PARTS LIST FOR MODEL SSV6500LL

MRP Ver 061514
(based on Penn's Rev. 2 10-10-12)

Penn Reel Parts list for Model: SSV6500LL Spinfisher V Live Liner

DESIGN CHANGES

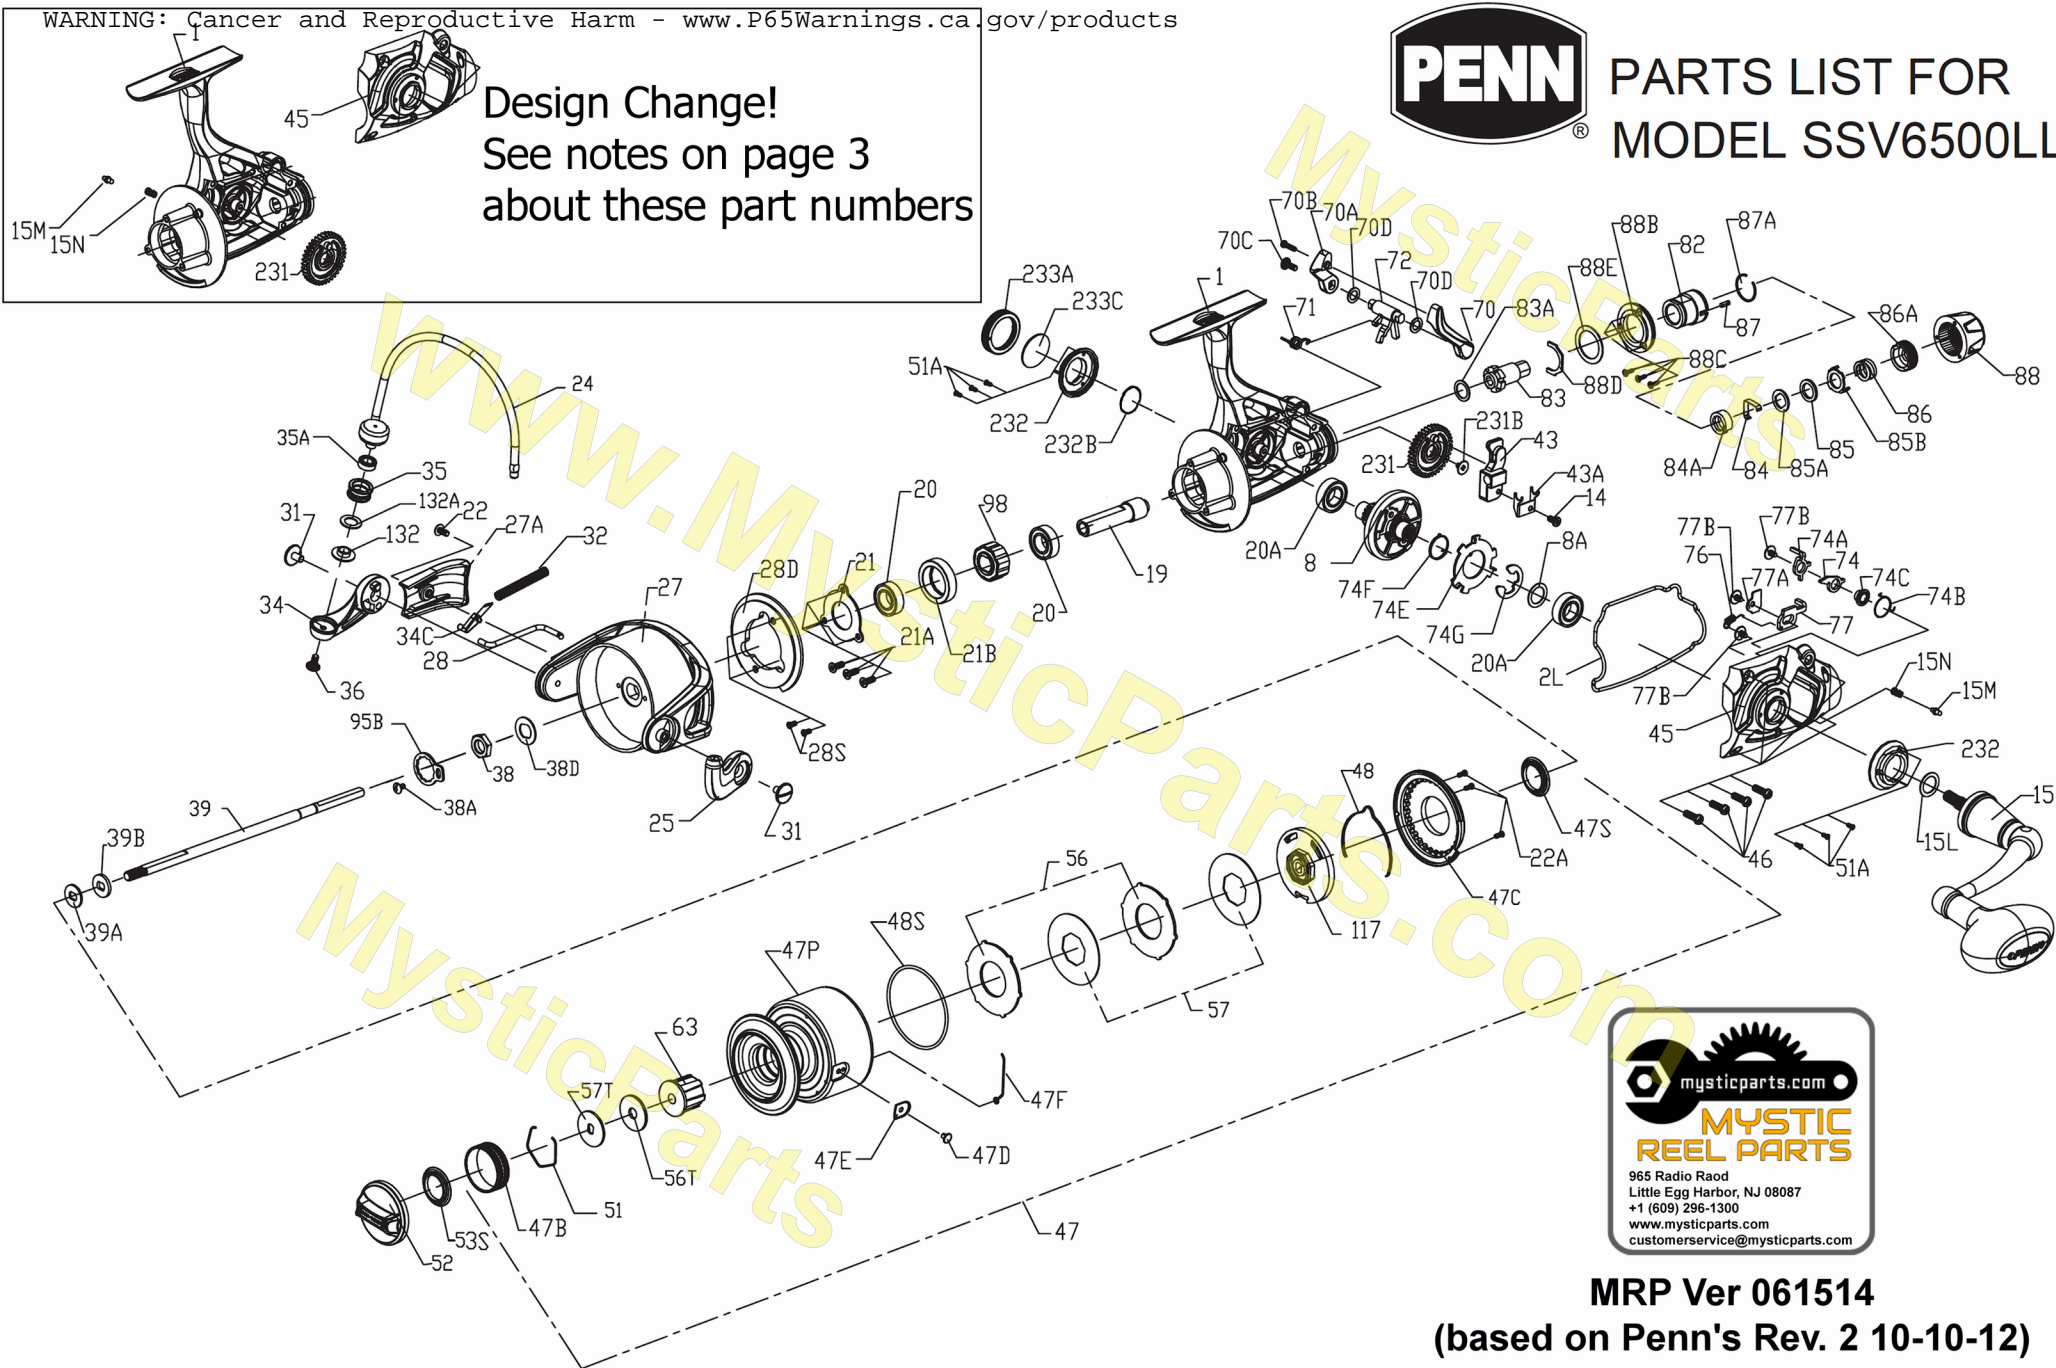
Design Change!
See notes on page 3
about these part numbers

REV 3. Bearing number changes ----->

We are assuming there were errors with the bearing part numbers on the schematic, rather than that they actually changed the bearings.

Early SSV6500LL run had a slightly different housing and crosswind gear. The diameter of the hole in the crosswind was almost 3/8". Later runs, the crosswind gear and the pin in the housing that it sits on must have been changed. The current gear I.D. is .23" just under 1/4", current housing matches it.

70D, 74 AND 74B PART NUMBERS CORRECTED BY PENN

RECOMMEND TO USE THE REVISION 5 NUMBERS

1	1277116	1-SSV6500LL	HOUSING, BODY ASSEMBLY with .23 peg
231	1277098	231-SSV5500	CROSSWIND OSCILLATION GEAR 0.23" I.D.
45	1277123	45-SSV6500LL	HOUSING / BODY COVER
1	n/a	1-SSV6500LL	HOUSING, BODY ASSEMBLY with .309 peg
231	n/a	231-SSV6500LL	CROSSWIND OSCILLATION GEAR 1st run 0.309" I.D.
45	n/a	45-SSV6500LL	HOUSING / BODY COVER
